PARTS LIST FOR MODEL SSV5500

MRP Ver 100314
(based on Penn's Rev. 4 10-01-14)

Penn Reel Parts list for Model: SSV5500 Spinfisher V

MYSTIC REEL PARTS REVISION!

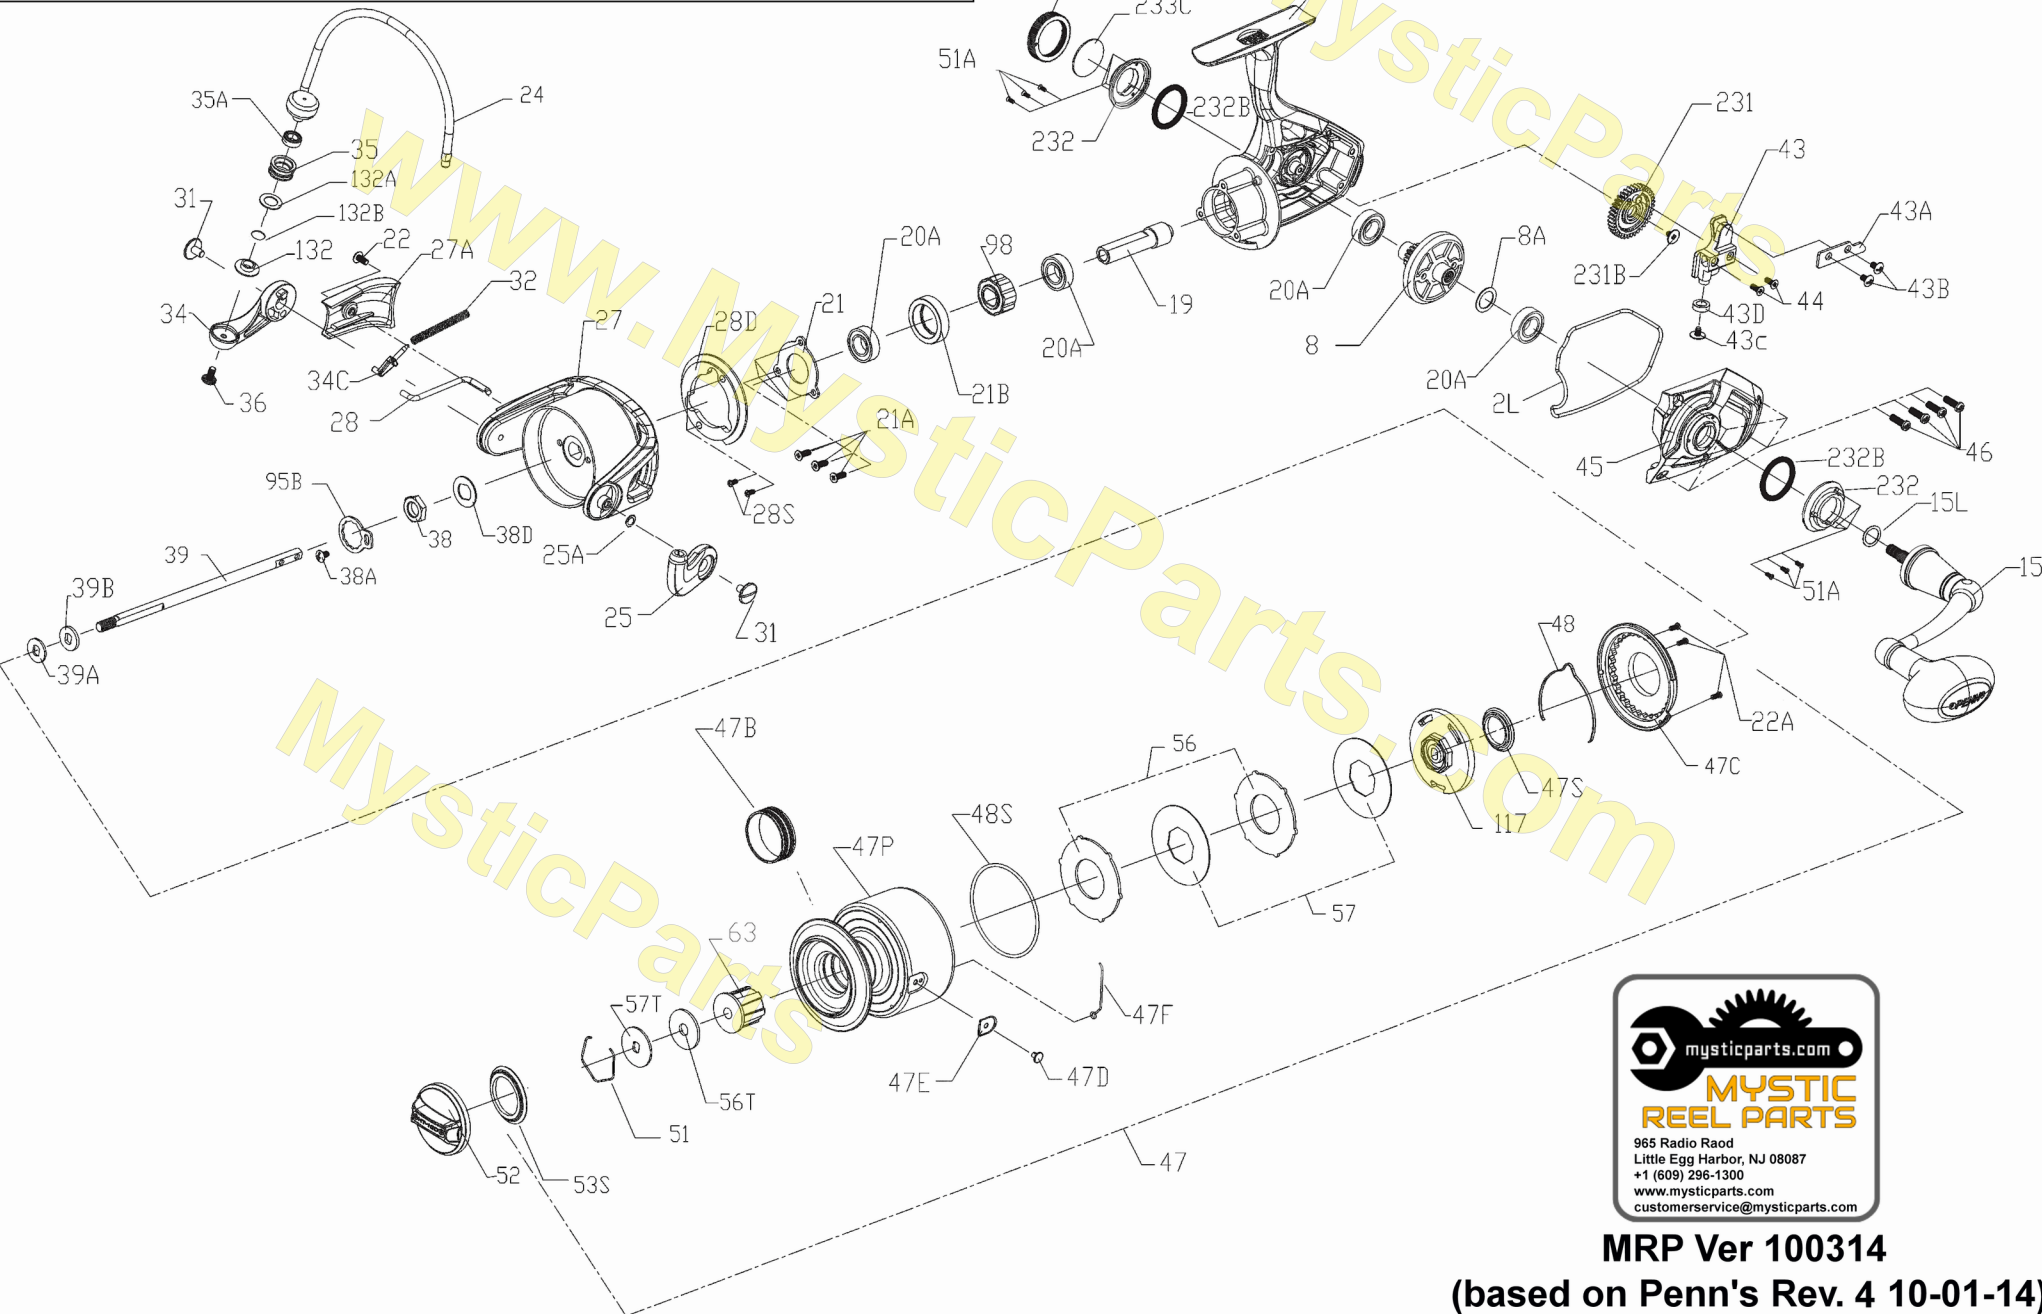
These parts below were removed by Rev 3, we are not yet sure why.

REV 3. Bearing number changes ----->

We are assuming there were errors with the bearing part numbers on the schematic, rather than that they actually changed the bearings.

Early SSV reels when released had a slightly different housing, crosswind gear and housing cover

The diameter of the CW gear hole and post was CHANGED and the pin/pin hole diameters on the 45- cover were changed as well

THIS DESIGN CHANGE affects the housing, crosswind gear, and housing cover

MEASURE YOUR HOUSING/GEAR

At the post where the crosswind sits or the hole in the center of the crosswind gear.

RECOMMEND TO USE THE REVISION 4 NUMBERS

1	1277034	1-SSV5500	HOUSING, BODY ASSEMBLY with .23 peg (1/4")
231	1277098	231-SSV5500	CROSSWIND OSCILLATION GEAR 0.23" I.D. (1/4")
45	1277073	45-SSV5500	HOUSING / BODY COVER to match (1/4")
231B	1307857	231B-SSV3500	CROSSWIND OSCILLATION GEAR SCREW (1/4")

1	NLA **	1-SSV5500	HOUSING, BODY ASSEMBLY with .309 peg (5/16")
231	NLA **	231-SSV5500	CROSSWIND OSCILLATION GEAR 1st run 0.309" I.D. (5/16")
45	NLA **	45-SSV5500	HOUSING / BODY COVER to match (5/16")
231B	1277100	231B-SSV5500	CROSSWIND OSCILLATION GEAR SCREW (5/16")
